TECHNICAL INFORMATION

| Range H&C | Model Z3000 VARIABLE CHAMBER UNIT | T.I. Nr 19_2011 |
| Serial Number 11811875 | Subject <u>SPRING PLATE</u> | Complaint Nr N 10/150 |

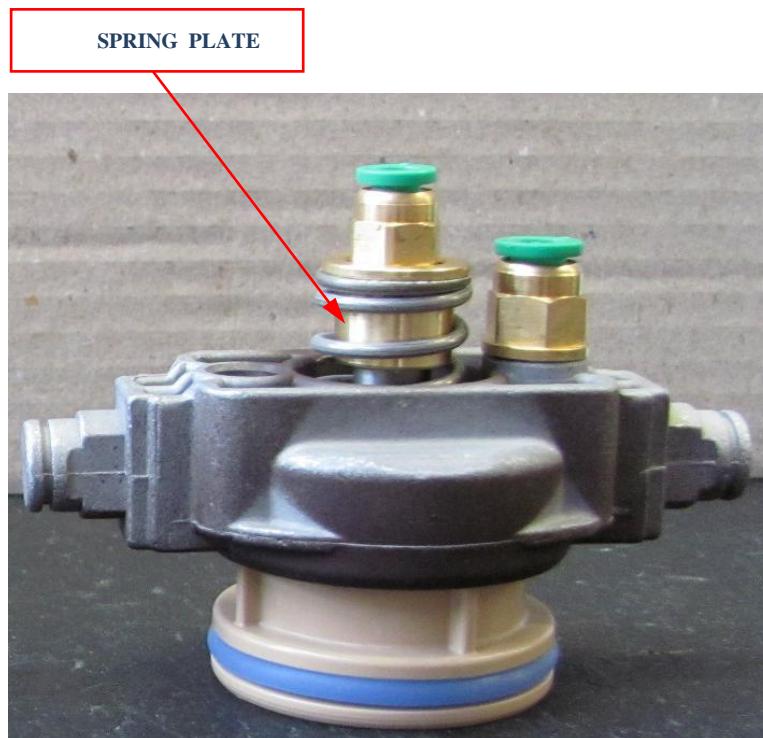
In order to reinforce the spring plate used on Z3000 variable chamber unit, the material of that plate (NEW SPARE **255649**) has been changed from plastic to brass.

Implementation is effective starting from S/N **11811875**.
